Bristol Airport Expansion to 12 million passengers per annum Planning Appeal

Rebuttal Proof of Scott Witchalls

On behalf of **Bristol Airport Limited**

Project Ref: 332110139/5502 | Rev: - | Date: July 2021

Figure 2.1 – LinSig Queue Charts (2030 Test Case – PM Peak Period)

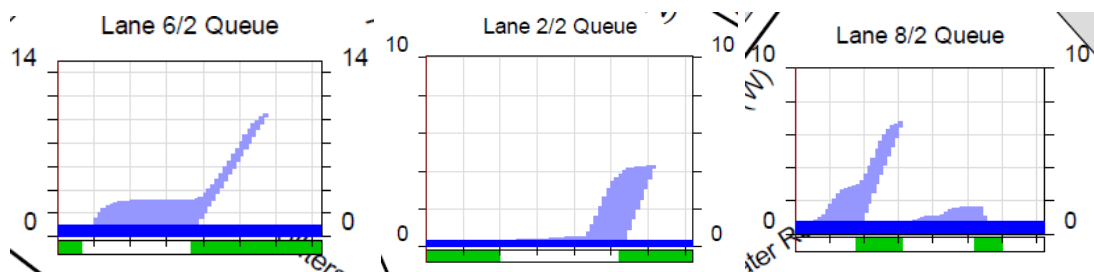
2.2.91 Mr. Colles states (para. 4.17.1) that *“The results provided in Appendix J show that in the AM and PM peak hours, internal queues exceed the lane lengths on several arms. The signalised roundabout would therefore become blocked and not operate within capacity. The junction capacity analysis therefore needs to be corrected which is expected to demonstrate the junction does not work within capacity and would therefore be contrary to policies NPPF Paragraph 108. c), CS10 and CS23 and would result in an unstable network affecting journey time reliability resulting in unacceptable queues and delays.”*

2.2.92 The LinSig models were set up agreed with NSC and Jacobs. A more detailed examination of the LinSig output clearly shows that that the maximum queues Mr Colles states would block the roundabout are simply ‘moving queues’ of traffic discharging during a green wave on the roundabout. The peak queues are there for a matter of seconds and are fully discharged (cleared) during each green wave. Entry and circulating green phases are synchronised to ensure that main traffic flows are not arriving at internal stoplines when a red signal is displayed, so no blocking will occur (**Appendix I**).

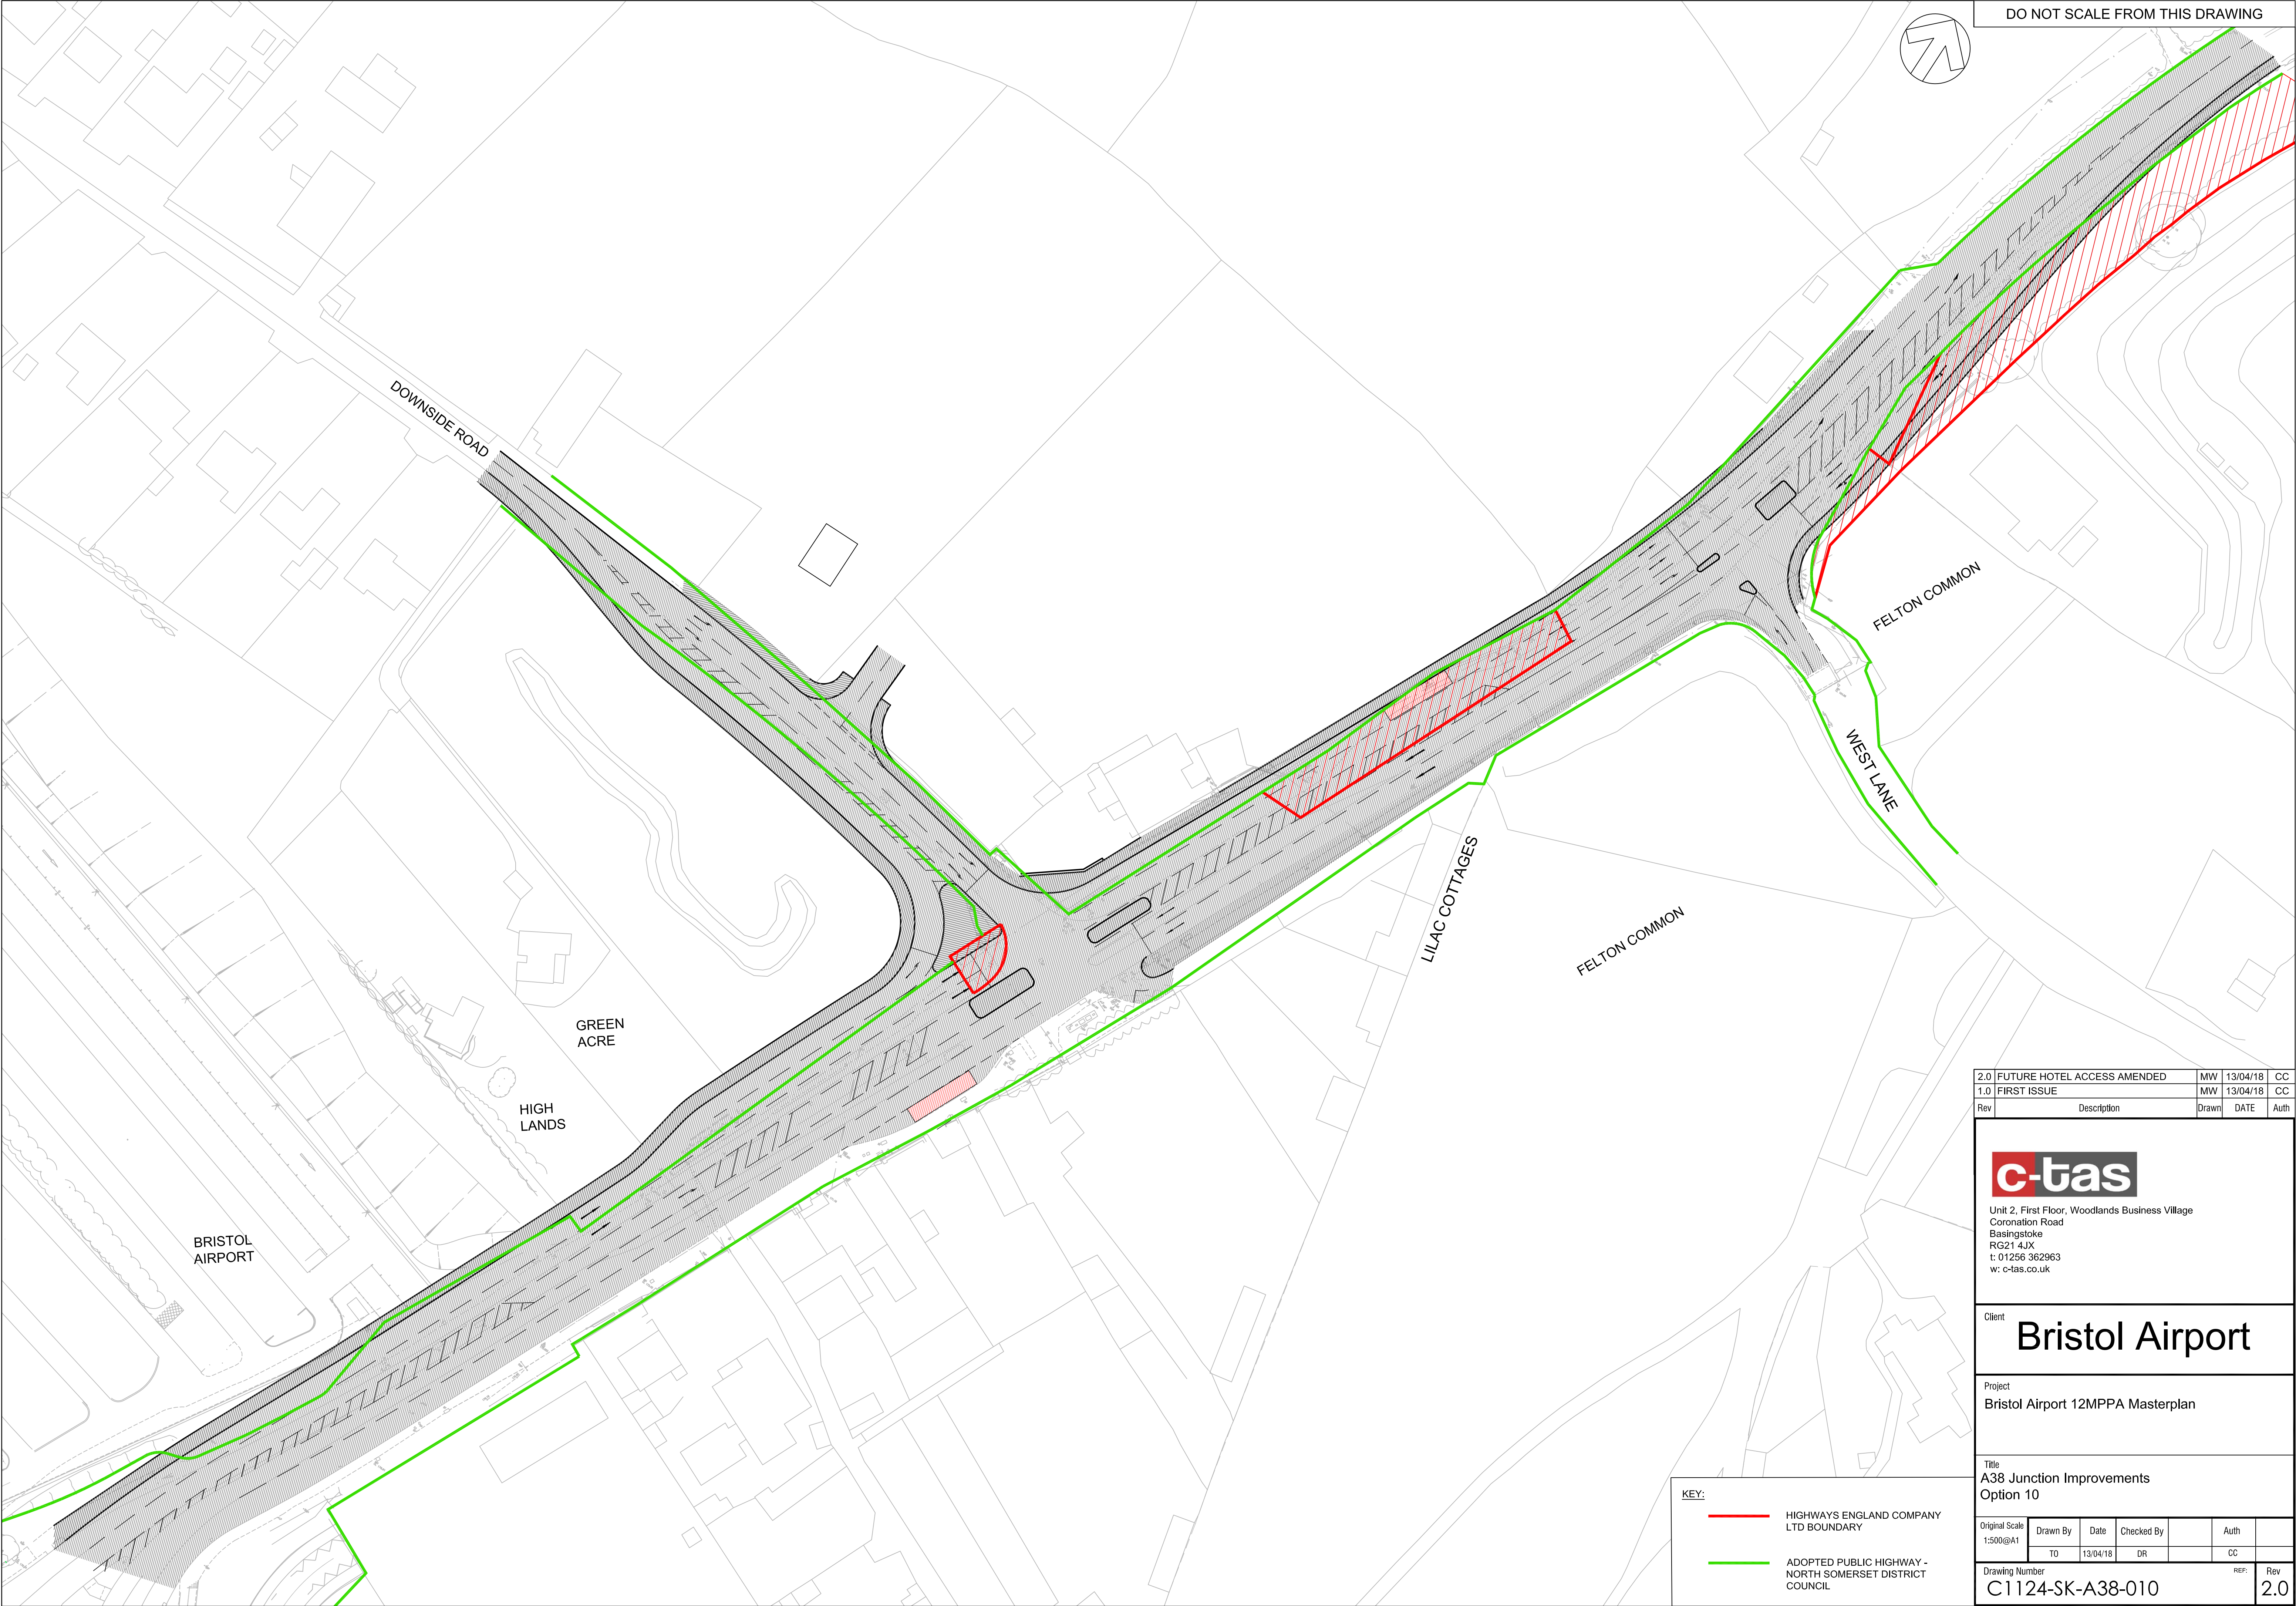
- 6.1. C-TAS Drawing C1124-SK-A38-010 sets out the outline junction proposals presented by the airport; covering the A38 / West Lane and A38 / Downside Road junctions. The airport’s proposals widen the existing A38 to four running lanes, with additional turning lanes at both junctions and hatching separating the northbound and southbound lanes.

- 6.8. The level of information provided about the LINSIG modelling is not sufficient to determine its appropriateness / robustness. It is recommended that further information is provided on the LINSIG models to allow further review

7.1. The following additional information is suggested from the design consultant to enable clarification of the proposed scheme:

- Ground levels at edge of carriageway and structures;
- Changes to the Airport Tavern car park access;
- Justification/evidence base for the removal of a formal pedestrian crossings and why none are provided in the proposed scheme at either Downside Road or West Lane;
